Product Change Notification

Date Issued :	January 22, 2025	PCN Number :	516176
Reason for Change :	Change to Product		
Description of Change :	This notification is to inform you about changes that are being made to the part(s) as identified in the list. this change will not affect the Fit,Form,Function, only the appearance of the parts.		
Assessment of Change :	No change to parts - Form/Fit/Function		
Planned Implementation Date :	July 22, 2025		
Customer Sample Availability Date:	February 25, 2025		
Last date to request Samples by Customer :	February 25, 2025		
Please note if Samples are not requested as per Customer Samples Request date, it may take additional 4-6 weeks to arrange Samples.			
Traceability Code Markings / Date :	Date code

1716920200/PSD/Revision A

Before Picture

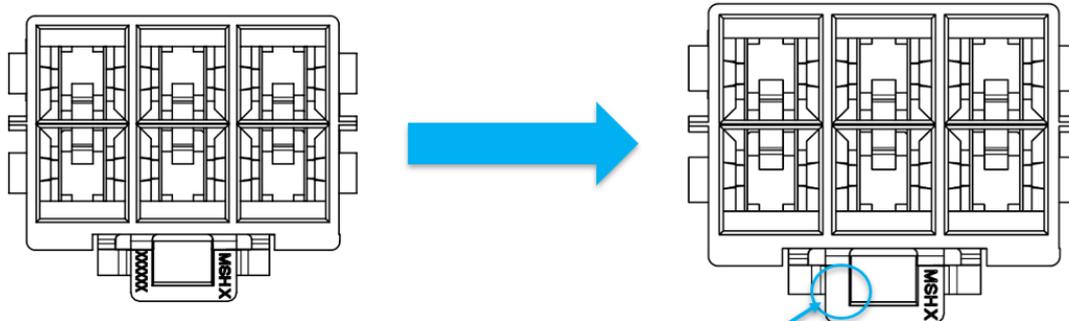
Remove series number mark

- The reason of the change:
Remove mark to improve mold inserts strength to improve yield rate and increase more output, it doesn't affect the product functionality.
- Product Impact
No impact to fit, form or function
- Part Number Impact
1716920202, 1716920204, 1716920206, 1716920208, 1716920210, 1716920212
- Qualification Reports, PPAPs, and samples available upon request (after the date(s) shown above)
